**From:** Thomas Saporito <saprodani@gmail.com>  
**Sent:** Wednesday, September 03, 2014 4:59 PM  
**To:** Klett, Audrey  
**Cc:** Hanks, Patrick; Kelly, JR  
**Subject:** Attachment - Presentation Outline to the 2.206 Enforcement Petition  
**Attachments:** 2014.09.03 NRC PRB (Turkey Point)(outline).pdf

September 3<sup>rd</sup>, 2014  
NRC Petition Review Board Meeting  
{2.206 Petition – Turkey Point Nuclear Plant}

Time Series Temperature Plot

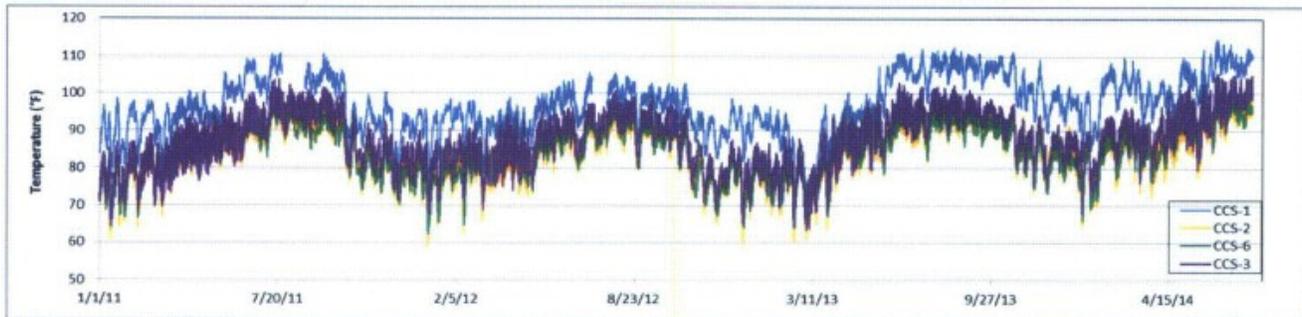
Now, if you look closely at the licensee's temperature plot, it can be determined that following the licensee's June 2013 uprate at the Turkey Point Nuclear Plant the canal water temperature has consistently visited a value at or above 100°F. It appears that the Turkey Point uprate significantly contributed to the increased canal water temperature.

The Petitioner contends here that not only is this consistently high canal water temperature a danger to the wildlife that lives in the canal, it poses a serious threat to continued licensed operations of the Turkey Point Nuclear Plant.

For this reason standing alone, the NRC should grant the requests outlined in the 2.206 Enforcement Petition to protect public health and safety and the environment and require the licensee to have a contractor independently investigate the “root-cause” of the increase in the canal water temperature.
